October 20, 2022

**Subject: Sudbury-Hudson Transmission Reliability Project (DEP File # 301-1287)  
Snow Removal Plan and Request for Minor Change to Equipment Storage  
Condition**

3	PATH REALIGNMENT 710+50 TO 713+50	08/19/2022	
N.O.	DESCRIPTION	BY	DATE
	REVISION		APPR.

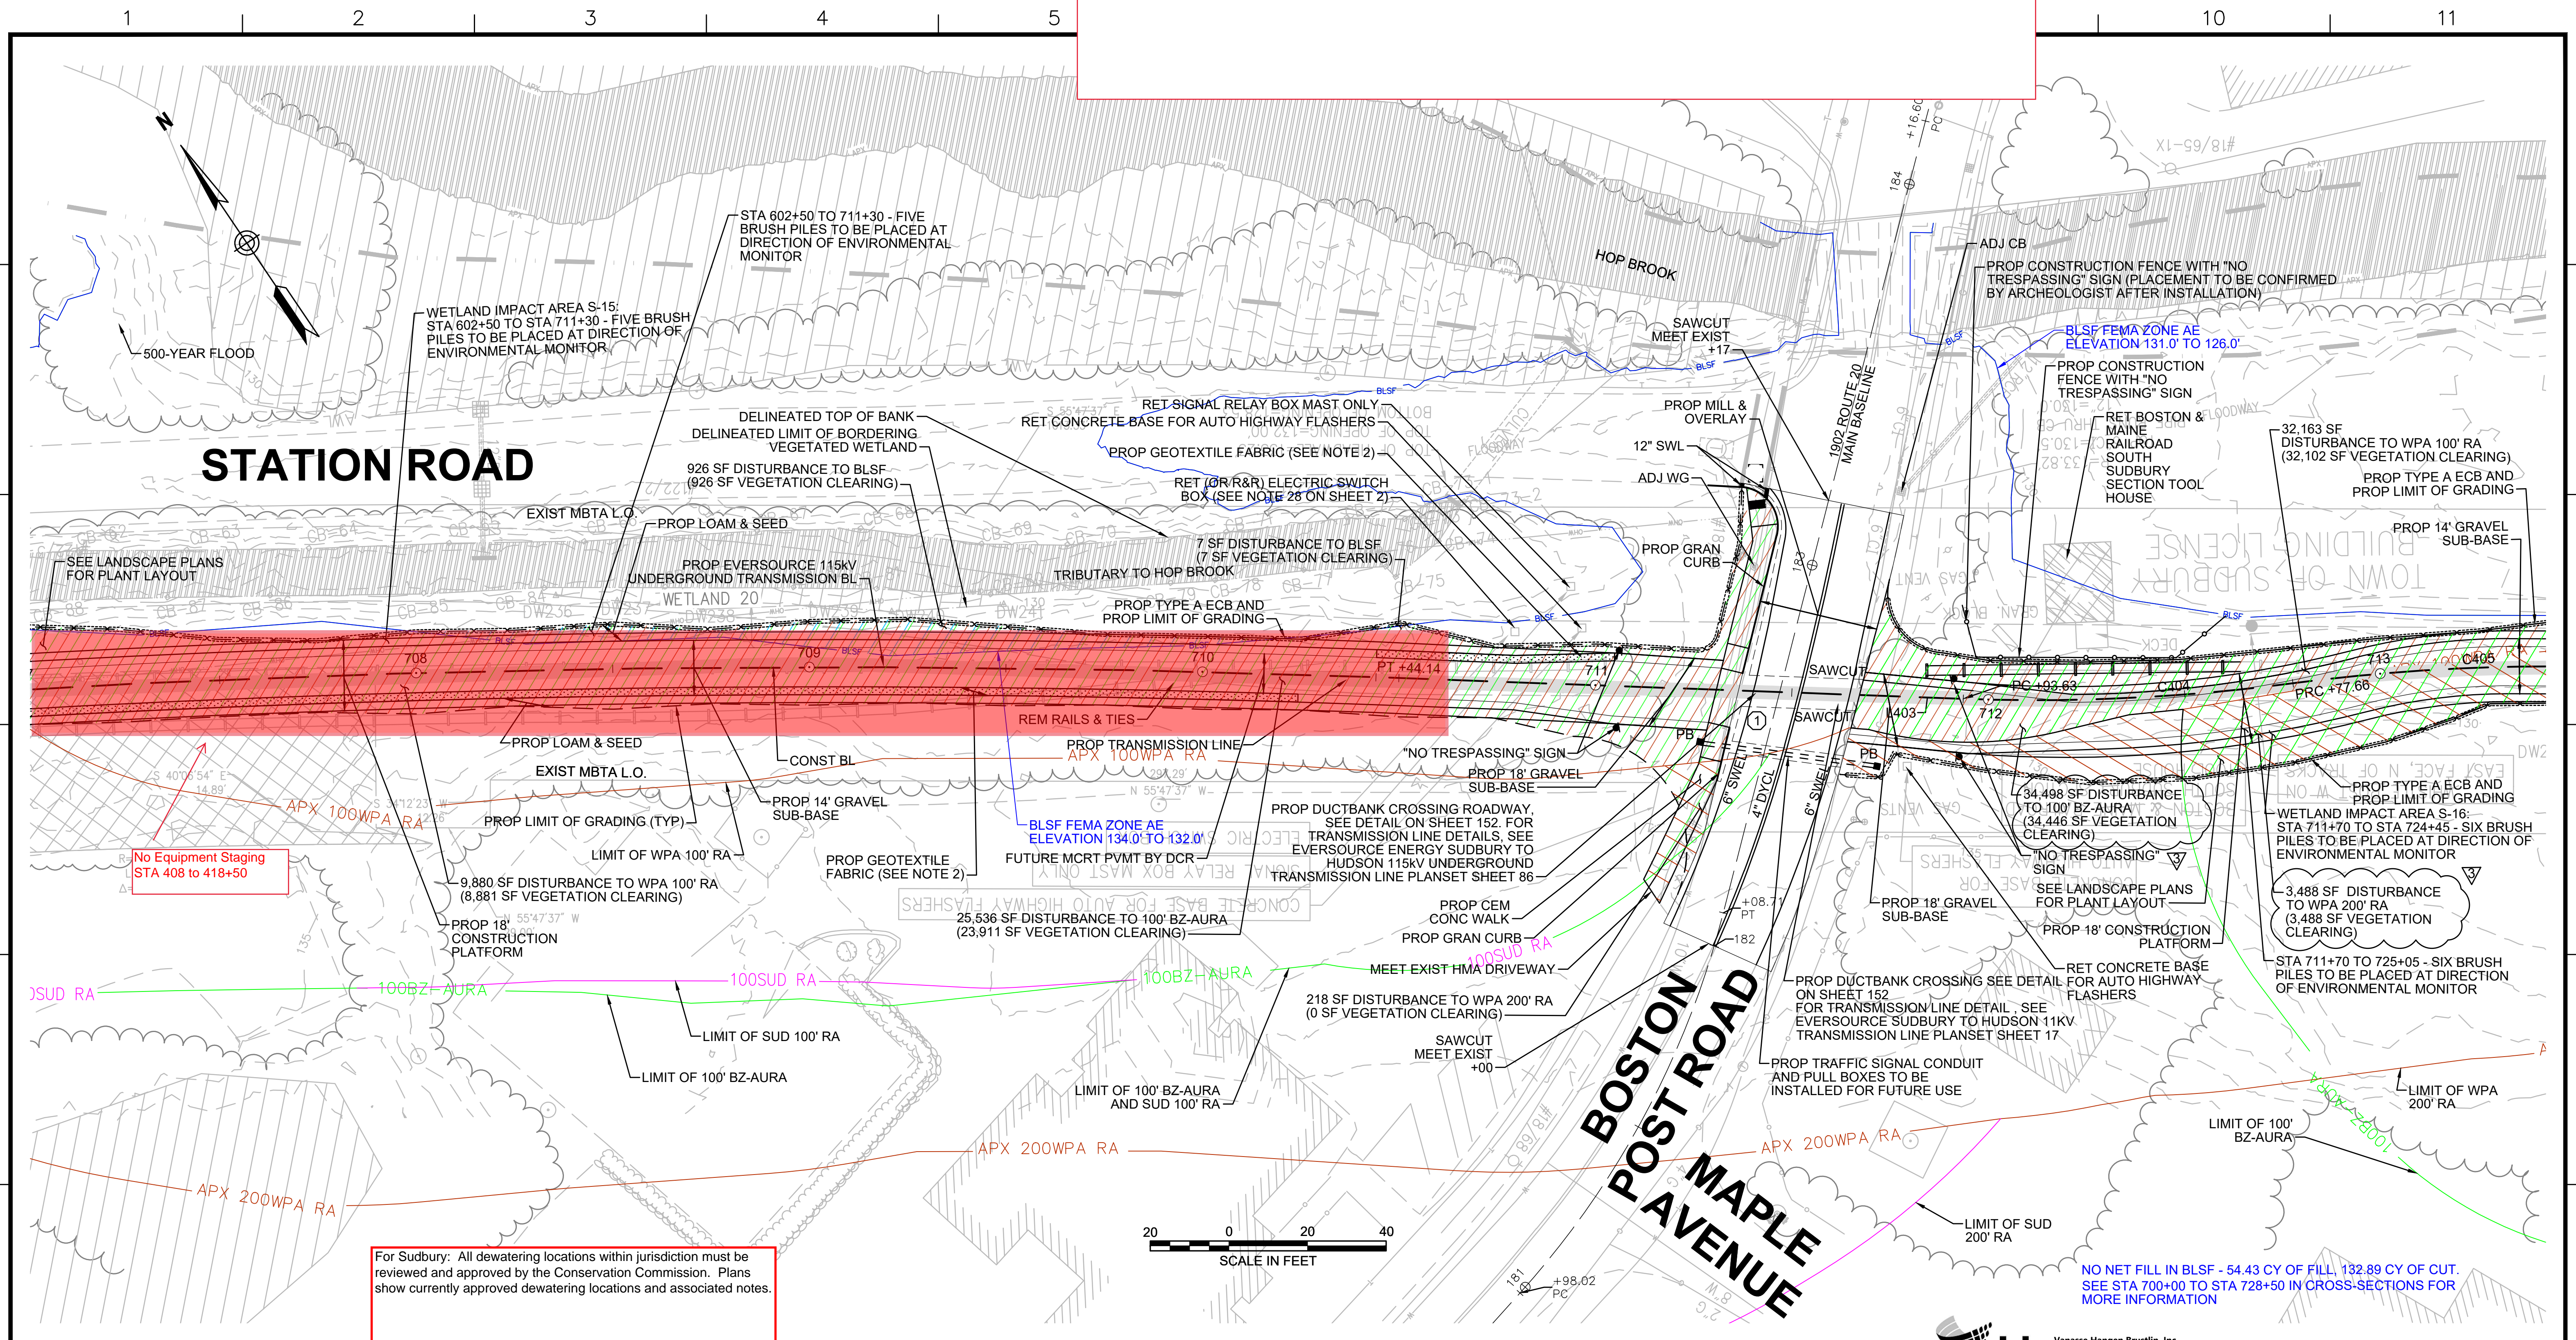
This duplicate sheet shows the change in limits of work at the tool house (east side of Boston Post Road)  
Need to retain or remove and replace section of track in front of tool house
